**IN THE MATTER** of the hearing of submissions on Plan Change 14 (Housing and Business Choice) to the Christchurch District Plan

**MEMORANDUM OF COUNSEL FOR CHRISTCHURCH CITY COUNCIL  
REGARDING FINAL CLARIFICATIONS SOUGHT**

20 September 2024

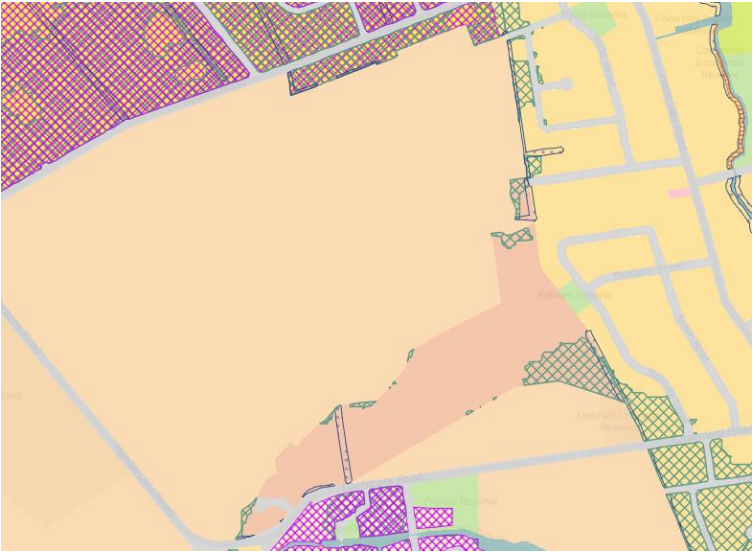
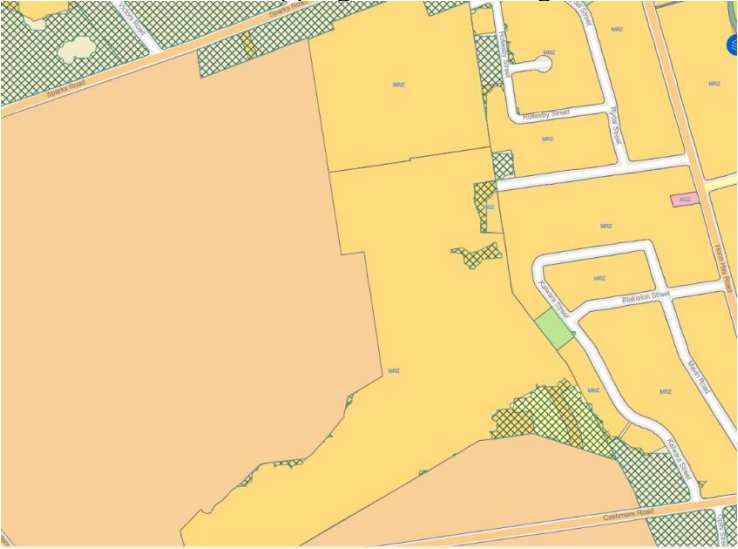
#	Area / Feature	Change required	Source / consequential change
		<p style="text-align: center;"><b>Council Reply</b></p> 	
3.	159 Main Road	<ol style="list-style-type: none"> <li>1. Re-zone 159 Main Road from LCZ to Industrial General Zone.</li> <li>2. Sites either side shown MRZ sites should also be zoned Industrial General Zone – to the same extent as the operative zone (i.e retain operative IG zone).</li> <li>3. The Industrial Interface QM should be removed from any non-residential zone accordingly.</li> </ol>	Response to Minute 53
